Per Calpine Corporation's direction and request, URS Corporation hereby submits 15 hardcopies and one CD containing the electronic files of the final Data Responses (Package No. 2) to address formal and informal Data Requests for the Pastoria Energy Facility 160 MW Expansion Project AFC (05-AFC-1). These final responses and supporting information attachments are the Data Responses that were not yet addressed as of the CEC Issues Workshop, held on July 26, 2005. The hardcopies of this Data Response Package No. 2 shall be docketed on Friday, August 12th.

**PASTORIA ENERGY FACILITY 160 MW EXPANSION
DATA REQUEST PACKAGE No. 2
05-AFC-1**

FIGURE 1

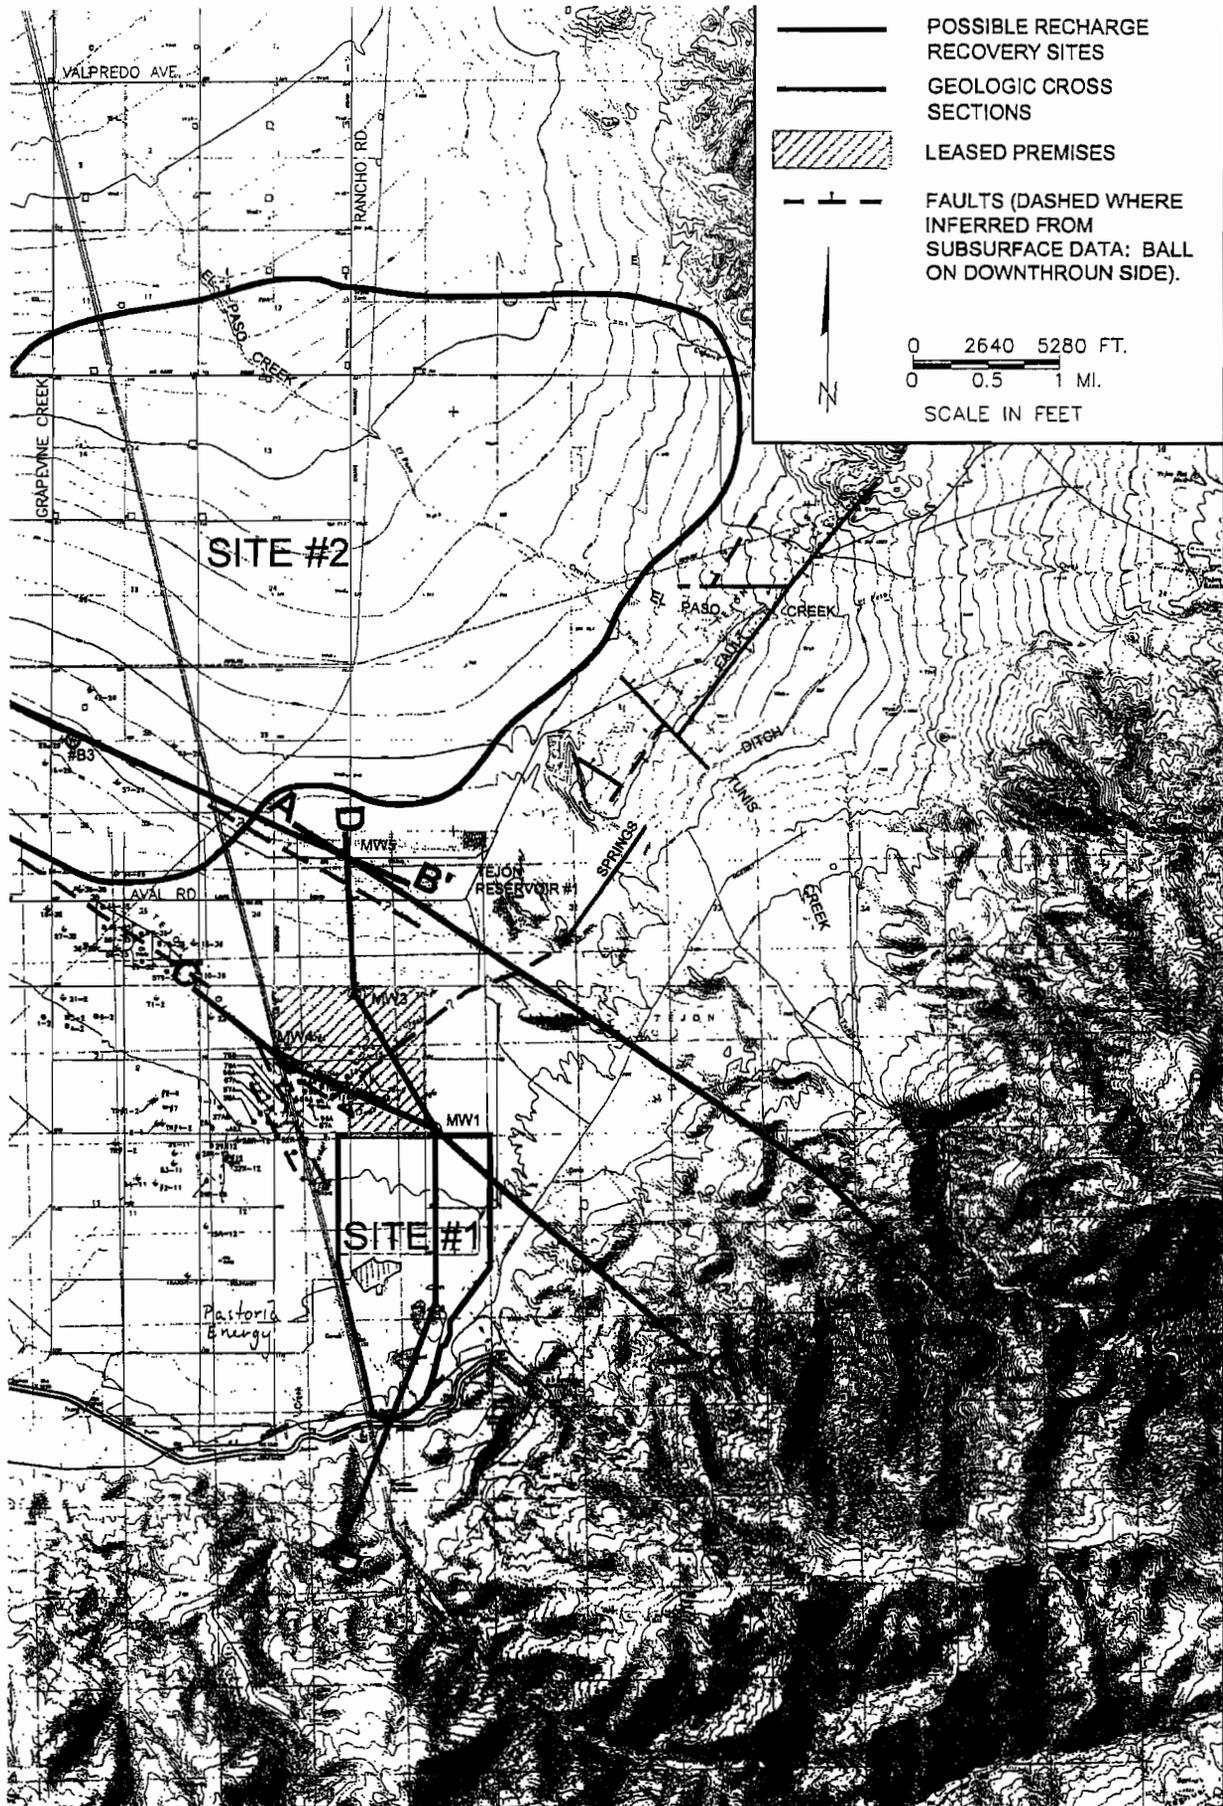
42. Please provide a description of the chemical characteristics of the groundwater.

A map confirming the location of the cross section view line for the two previously submitted cross sections displaying the geology and groundwater conditions is provided in this Data Response Package as Attachment SOIWR-42a.

Following is a location map for geologic cross section D-D' on legal size paper. I hope this serves your purposes. The map is a little busy. I could perhaps generate a cleaned up version, but it would require a day or two.

P.S.: The water chemistry that I ~~pre~~ previously transmitted was from the well labeled MW1 on this map.
